**ADDENDA
00 91 13**

Mechanical Addendum #M-01

The information listed below is to form part of the Contract Documents. All associated costs are to be included in the Bid Price shown on the Bid Form. Acknowledgment of this Addendum, by number, is to be shown in the space provided on the Bid Form.

M1-01

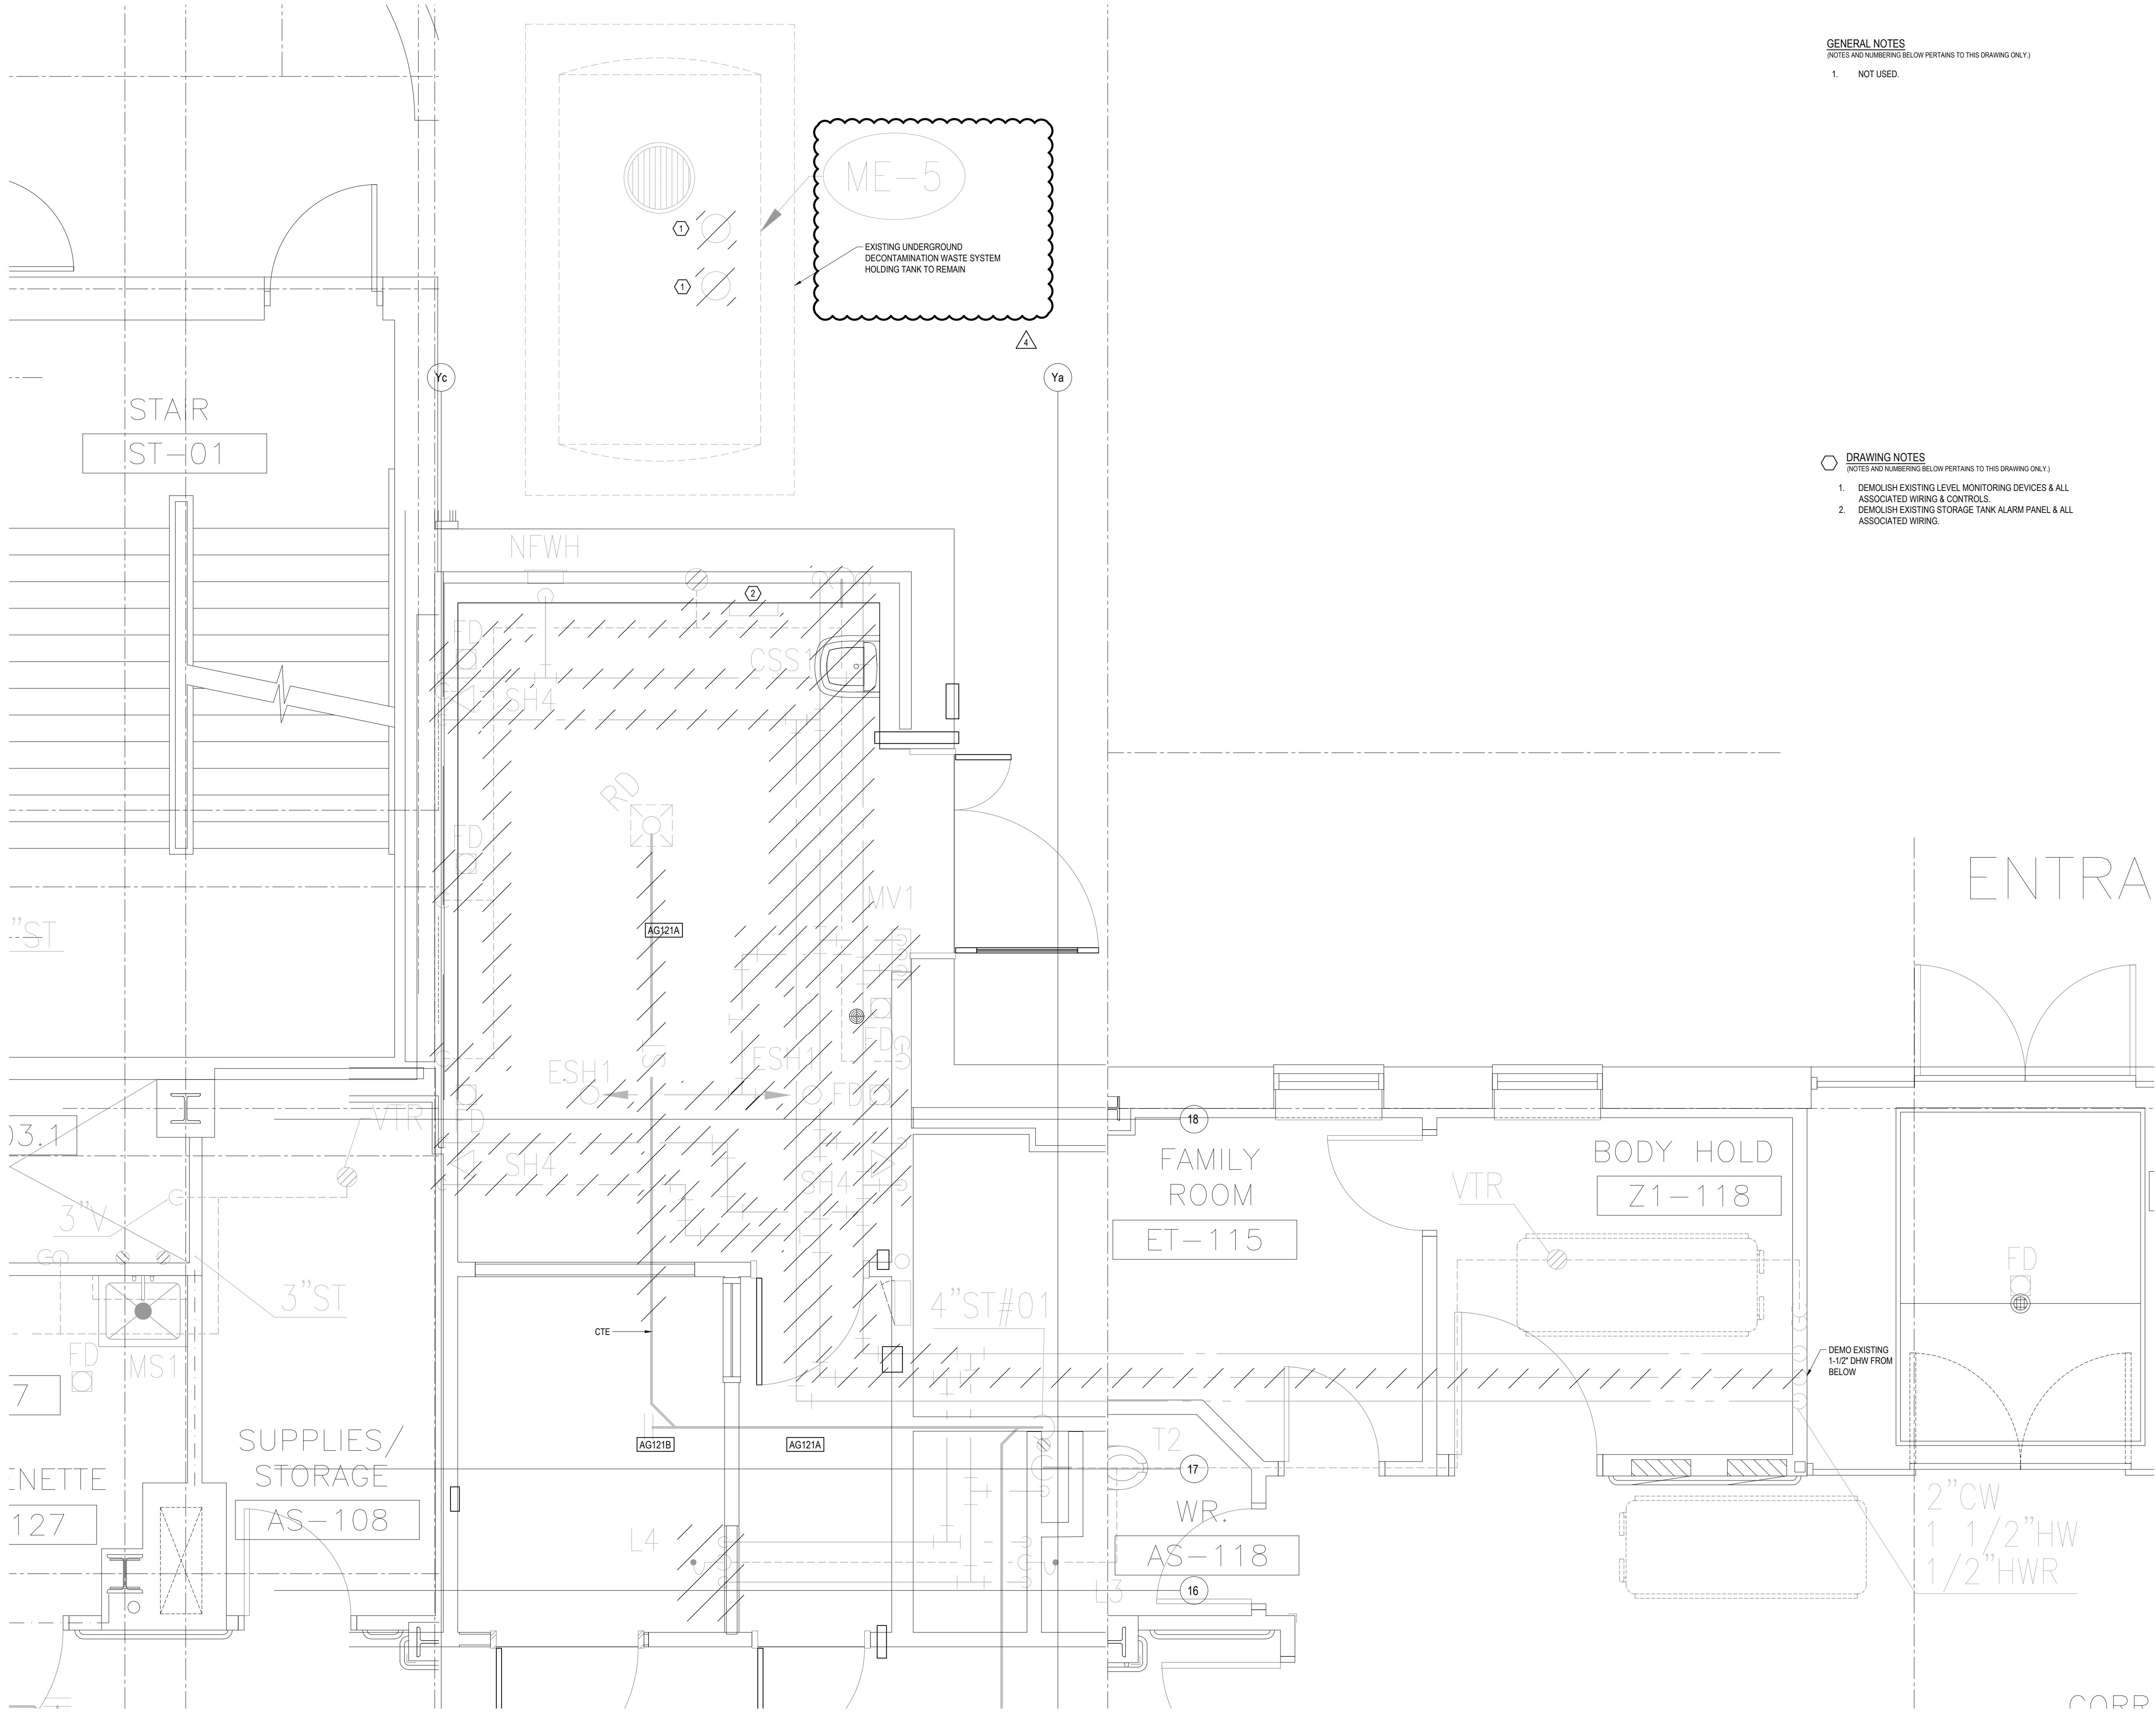
1) Please confirm whether the intent is for the connection to the contamination tank to be made from the exterior of the building.

- 3) Drawing M-1-01 says Decontamination tank is to remain AS IS - Please clarify. Is a new / additional Decontamination tank required during this project?

3.5 Reference Drawing M1-01 - DECONTAMINATION ROOM - BASEMENT PLUMBING - NEW WORK (reissued)

- .1 Delete verification of existing underground decontamination waste system holding tank.
- .2 Clarified where the slab-on-grade portion of the building begins and the extents of the crawl space.
- .3 Clarified where piping is exposed within the Storage Room ceiling vs. where piping is located within an existing T-bar ceiling.
- .4 Scale revised to 1:50 for clarity.

In response to sub-questions (a), (b), and (c): Drawing notes on drawings M1-00, M1-01, and M1-01 have been revised as part of this addendum to remove the verification requirement under this contract.

ANSWER: Decontamination Room AG121A is slab-on-grade. The intent is for the connection to the tank to be made below grade beyond the footprint of AG121A as shown on the Drawings M1-00 (Demo) and M1-01 (New). A new note has been added to M1-00 and M1-01 to clarify where the slab-on-grade area begins.

ANSWER: Existing Decontamination Tank is to remain; there is no scope for a new tank.

M1-03

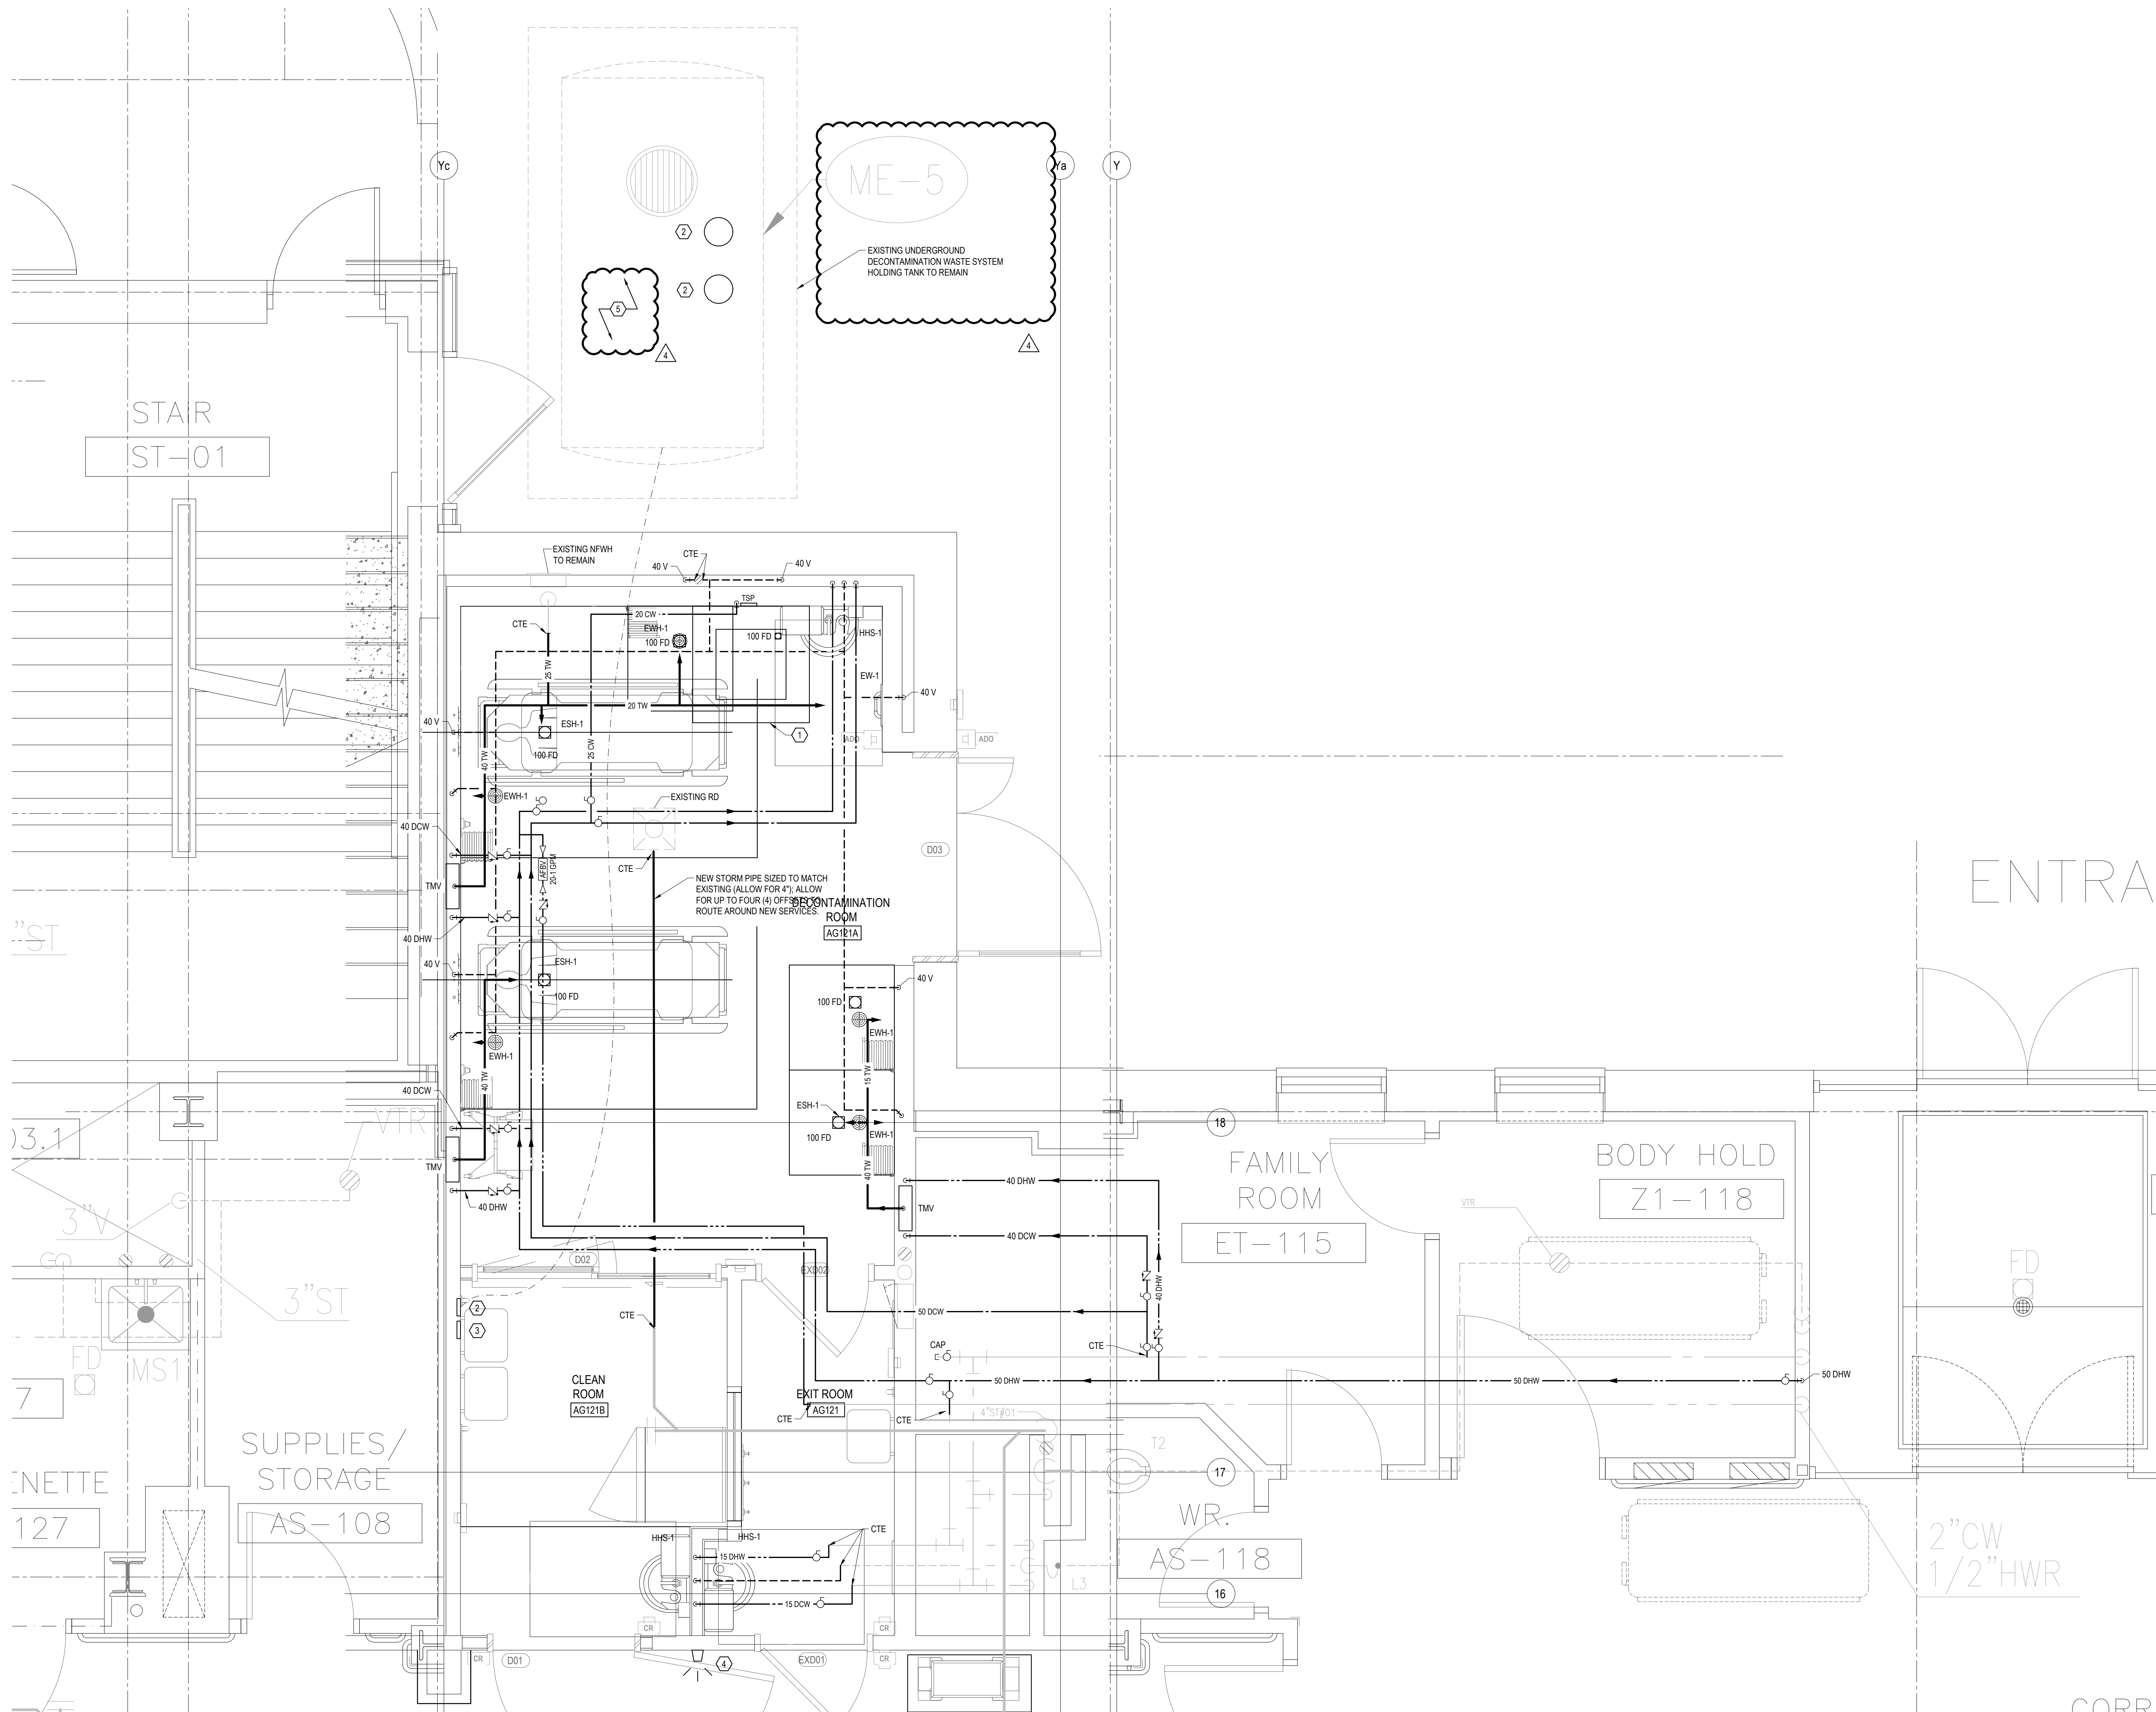
3.7 Reference Drawing M1-03 DECONTAMINATION ROOM - GROUND FLOOR PLUMBING - NEW WORK (reissued)

- .1 Delete verification of existing underground decontamination waste system holding tank.
- .2 Add Drawing Note #5: "THE CONTRACTOR IS TO EMPTY, CLEAN, AND DISPOSE OF EXISTING DECONTAMINATION TANK CONTENTS AS NECESSARY TO FACILITATE INSTALLATION OF NEW CONTROL DEVICES WITHIN TANK."

In response to sub-question (d), the contractor is to empty, clean, and dispose of existing contents as necessary to facilitate the new level alarm installation; this has been added to the drawing notes on Drawing M1-03 as part of this addendum.
